**ADDENDUM NO. 1 TO ALL BIDDERS:**

Invitation to Bid: **ITB No. SOL1254**

Description: **Public Works Service Center and Fire Stations 4 & 6 Fueling Improvements**

**ATTACHMENT A TO**  
**ITB NO. SOL1254**  
**PUBLIC WORKS SERVICE CENTER AND FIRE STATIONS 4 & 6 FUELING IMPROVEMENTS**  
**REVISED DRAWINGS**

SHEET NUMBER:  
**C004-PW**

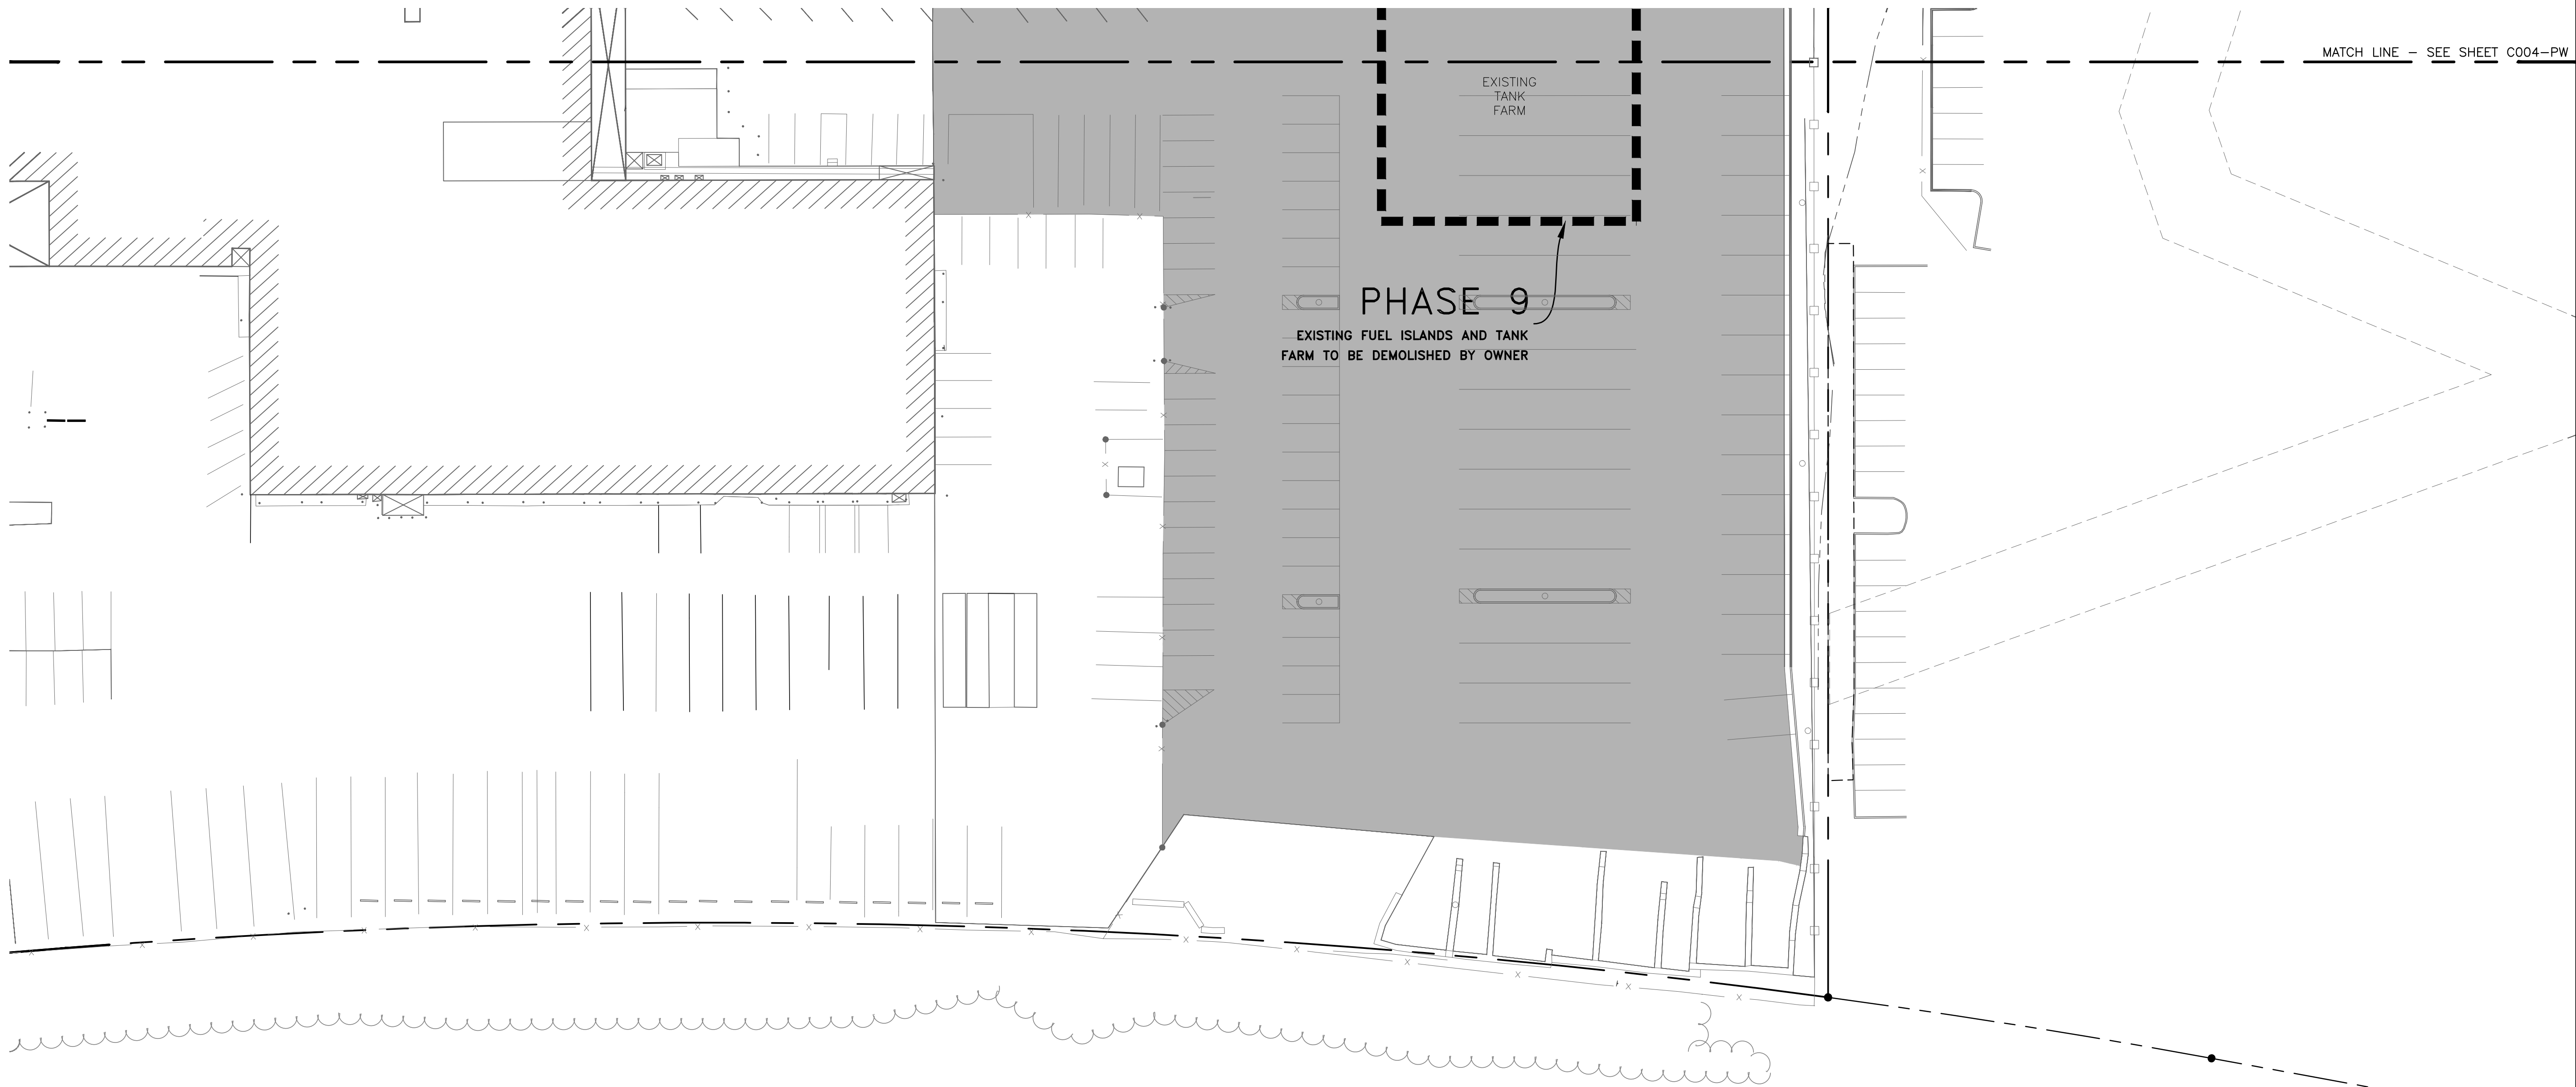
SHEET NO.	SHEET TITLE	DESCRIPTION OF CHANGE
C004-PW	PHASING PLAN	General notes 1 & 2 were added to instruct Contractor to coordinate a temporary work trailer location with the owner and coordinate temporary fencing with phasing.
C005-PW	PHASING PLAN	General notes 1 & 2 were added to instruct Contractor to coordinate a temporary work trailer location with the owner and coordinate temporary fencing with phasing.
C006-PW	EXISTING CONDITIONS & DEMOLITION PLAN	Additional fencing is to be demolished near the main building.
C101-PW	DIMENSIONAL LAYOUT & UTILITY PLAN	<ul style="list-style-type: none"><li>The path of the UGC running to the main building was adjusted to be out of the pavement and within the grass.</li><li>Additional fencing is to be constructed near the main building.</li><li>New sidewalk is shown past the existing entrance of parcel # 3070320 along Courtland Road, NE</li><li>Turn down sidewalk was added for a portion of the new sidewalk along Sycamore Avenue, NE.</li><li>Entry equipment for new automatic vehicular gate was moved from a standalone post to a concrete base. Equipment provided by the Owner, concrete shall be provided by the Contractor.</li></ul>

1. CONTRACTOR SHALL COORDINATE TEMPORARY WORK TRAILER LOCATION WITH OWNER.
2. CONTRACTOR SHALL PROVIDE TEMPORARY FENCING TO PROTECT THE WORK AREA AND ADJUST IN RELATION TO PHASING.

**7 TURN DOWN SIDEWALK**  
C101 C501 NO SCALE

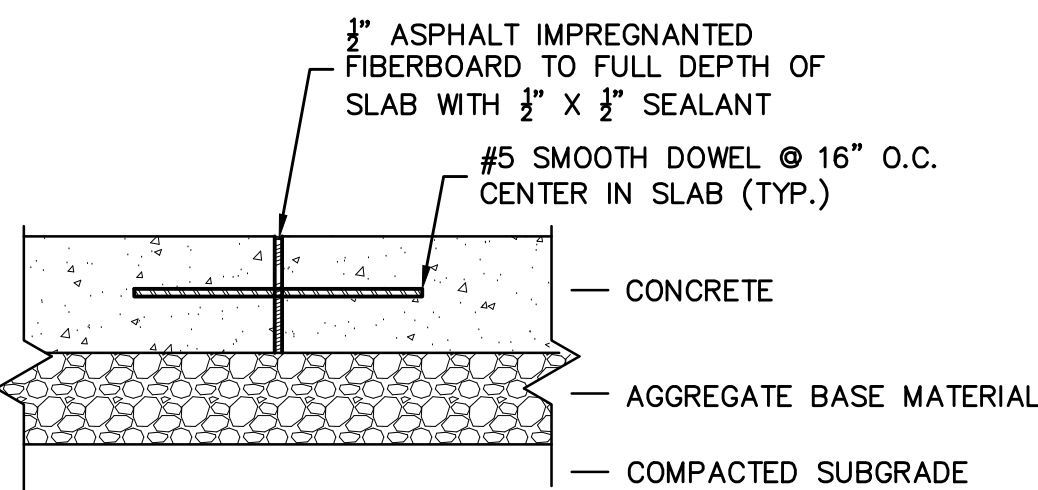
C501-PW	SITE DETAILS	Detail 7 was added for turn down sidewalk.
C502-PW	SITE DETAILS	Detail 1 was revised to show keyless entry controls.
A001-FS6	NOTES & SPECIFICATIONS	Monitoring systems section removed from table.
A001-PW	NOTES & SPECIFICATIONS	Dimensions added to heavy duty metal storage rack under equipment section.
E501-	ELECTRICAL –	Typical Grounding Detail added to the sheet.

SHEET NUMBER:  
E501-FS4

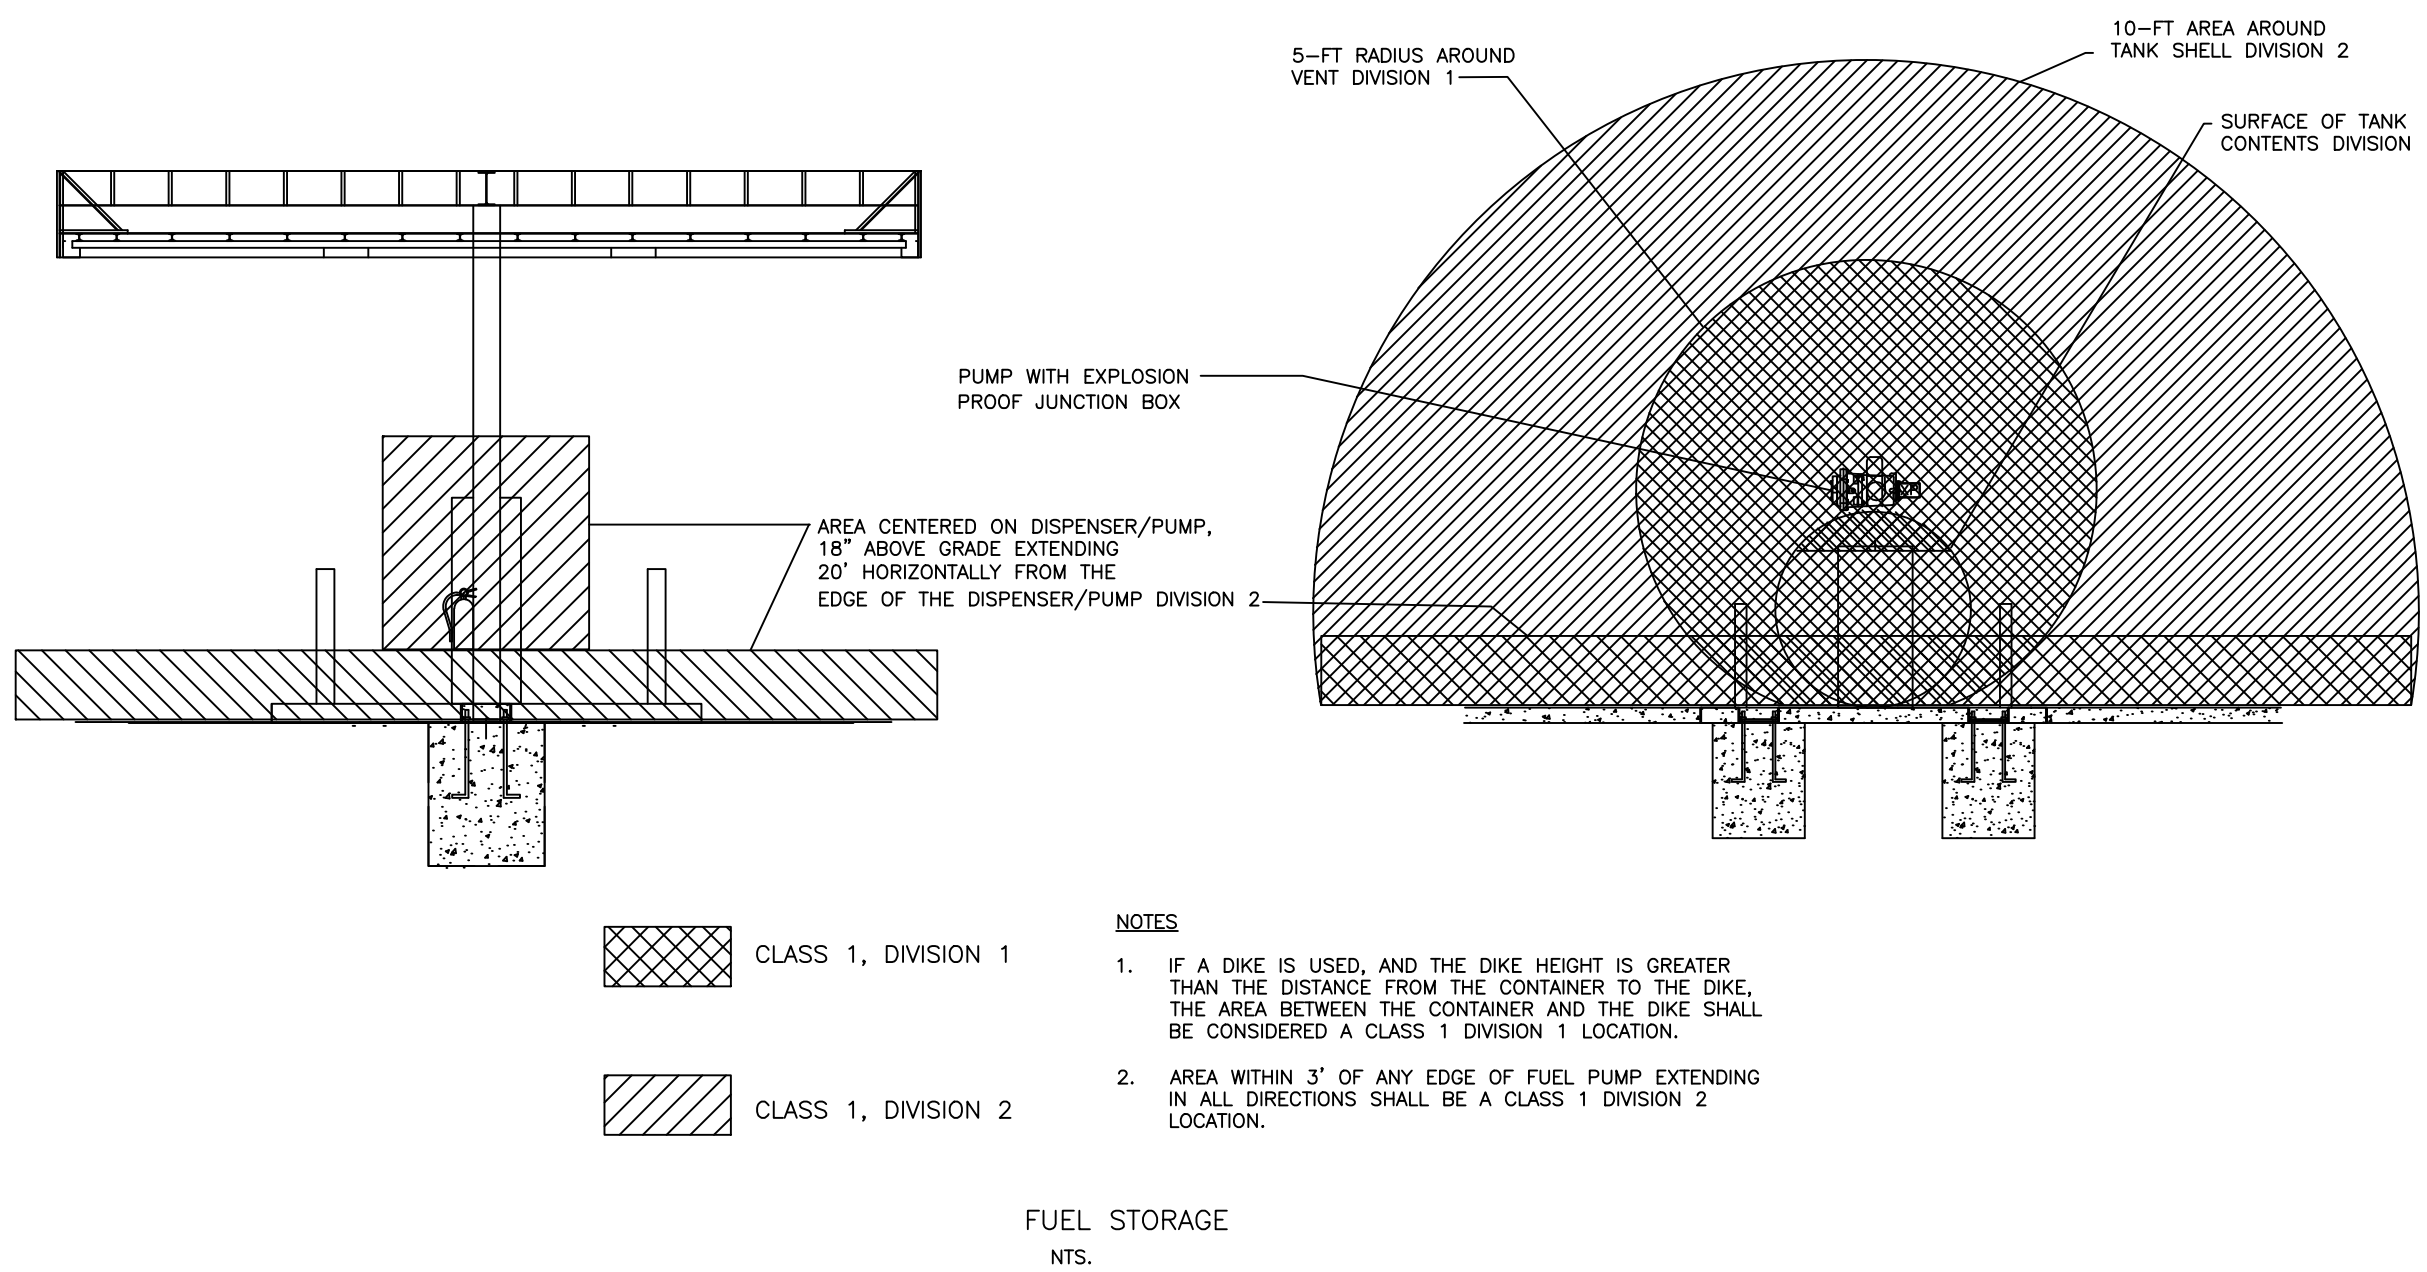
FS4	DETAILS	
E501-FS6	ELECTRICAL – DETAILS	Typical Grounding Detail added to the sheet.
E101-PW	ELECTRICAL – SITE PLAN	<ul style="list-style-type: none"> <li>• Sheet notes added/modified.</li> <li>• Conduits added for keyless entry at vehicular gate and pedestrian gate. Keyless entry equipment locations shown.</li> <li>• Conduits to vehicular gate operator were clarified.</li> <li>• Conduits to propane shown.</li> <li>• Conduit duct bank configurations modified (several places).</li> <li>• Conduit to main building relocated to be in the grass.</li> <li>• Conduit through main building to Telecom Room clarified.</li> </ul>
E102-PW	ELECTRICAL – SITE PLAN	<ul style="list-style-type: none"> <li>• Sheet notes added/modified</li> <li>• Conduit duct bank configurations modified (several places).</li> <li>• Two (2) camera locations added in lower lot.</li> </ul>
E502-PW	ELECTRICAL – DETAILS	<ul style="list-style-type: none"> <li>• Typical Grounding Detail added to the sheet.</li> <li>• Light pole base details modified to show security camera requirements.</li> </ul>
